**Car Stereo
Service Bulletin**

Model: CDX-A30

No. 143

Subject: High Pitch Noise During Playback

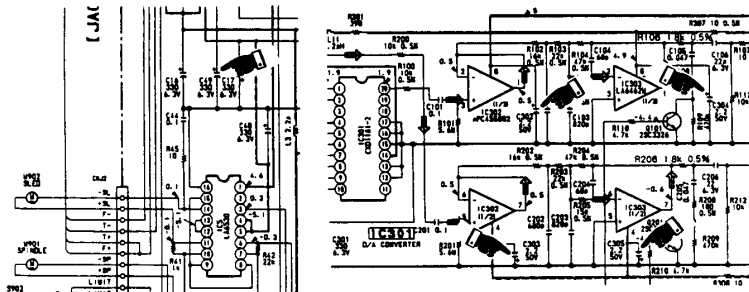
At high volume levels, a high pitch noise can be heard between tracks and during quiet passages. This noise may be difficult to hear at low or normal volume settings.

Cause:
The characteristics of the low-pass filter has changed.

Solution: Replace the chemical capacitors C49, C302, C303, C304, and C305 with the parts listed below:

| Ref. No. | Former Part | New Part | |
|---------------------------|-------------------|------------------|--------------|
| C49 | 3300 μ F/6.3V | 330 μ F/6.3V | 1-124-442-00 |
| C302, C303, C304, C305 | 100 μ F/6.3V | 2.2 μ F/50V | 1-124-257-00 |
